SERVICE - INFO

LuK Nr: 128 0055 11 – 280mm DBVR

Bulletin 988 2000 960

CASE IH, MANITOU, VOLVO**

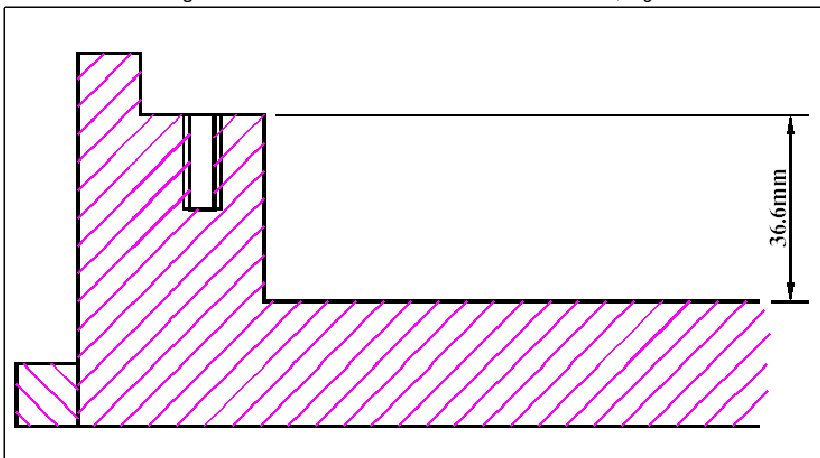
Info:	128 0055 11 replaces / ersetzt / remplace / sustituye a / sostituisce 128 0055 40 + 128 0055 41
(GB)	Please ensure that the flywheel is machined to a pot depth of 36.6mm.

(D)	Das Schwungrad ist auf eine Tiefe von 36.6mm auszdrehen,siehe unten.
(F)	Veillez vous assurer que le volant-moteur est rectifié à une profondeur de 36.6mm.

(E)	Asegúrese de que el volante está mecanizado hasta una profundidad de 36.6mm.
(I)	Controllare che il volano venga rettificato a una profondità di 36.6mm.
LuK Repsets:	628 1032 07 = 128 0055 11 + 328 0175 42 + 500 1046 50 + 410 0026 00 628 1032 09 = 128 0055 11 + 328 0175 42 628 1033 07 = 128 0055 11 + 328 0175 41 + 500 1046 50 + 410 0026 00 628 1033 09 = 128 0055 11 + 328 0175 41 628 2590 07 = 128 0055 11 + 328 0175 40 + 500 1046 50 + 410 0026 00 628 2590 09 = 128 0055 11 + 328 0175 40 628 2592 07 = 128 0055 11 + 328 0175 10 + 500 1046 50 + 410 0026 00 628 2592 09 = 128 0055 11 + 328 0175 10
	128 0055 11 – 128 0055 12 + 434 0342 10
